Subject: SunDome Module Shim

Number: SRV0015

Applicability: SunDome XL48
Sunvision Elite 48V
SunDome 548V
SolarSystem 48 VIP
SolarSystem 48 Platinum

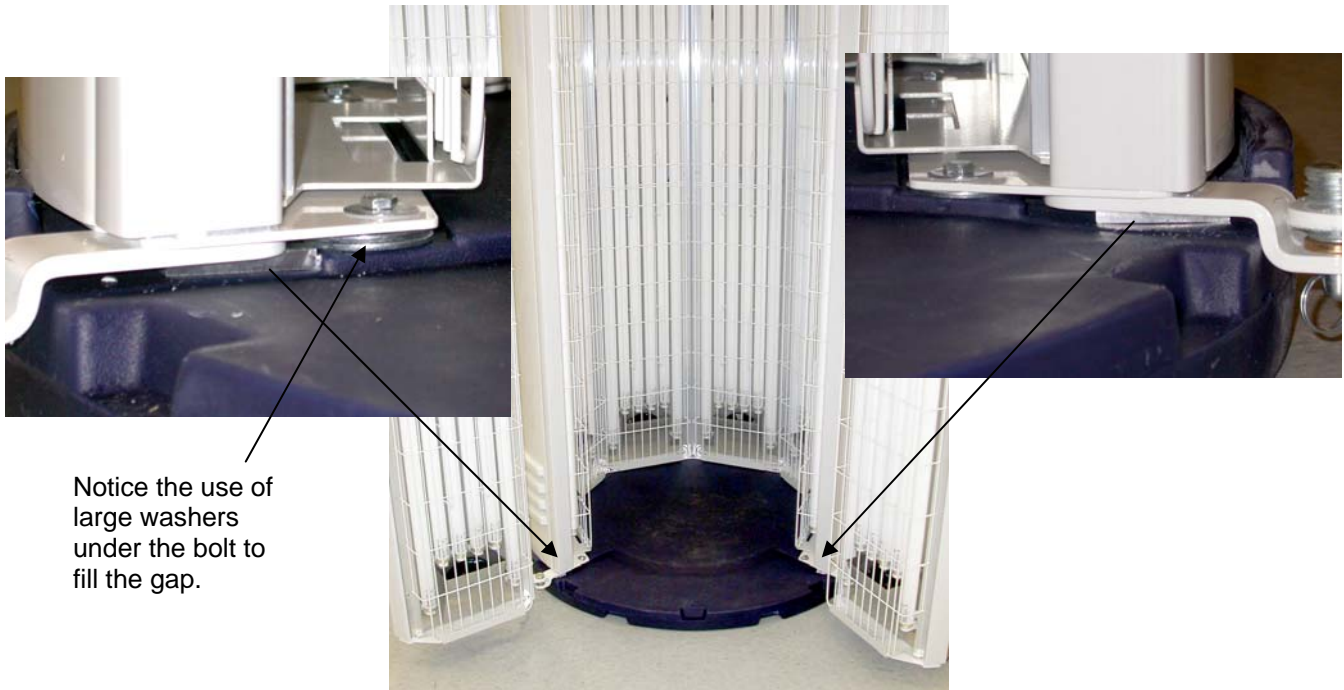
Symptoms: Booth doors are rubbing the front of the pedestal even though the doors have been shimmed at the hinge pins.

Explanation: The pedestal has been determined to be “out of spec” according to our Engineering prints.

Solution: Use a ¼” thick shim under the hinge plates on both sides of the booth (see photos below). This will raise the front of the modules and doors enough to clear the pedestal. A service kit is available from ETS, Inc., which includes two shims and an instruction sheet, if needed.

Notice the use of large washers under the bolt to fill the gap.
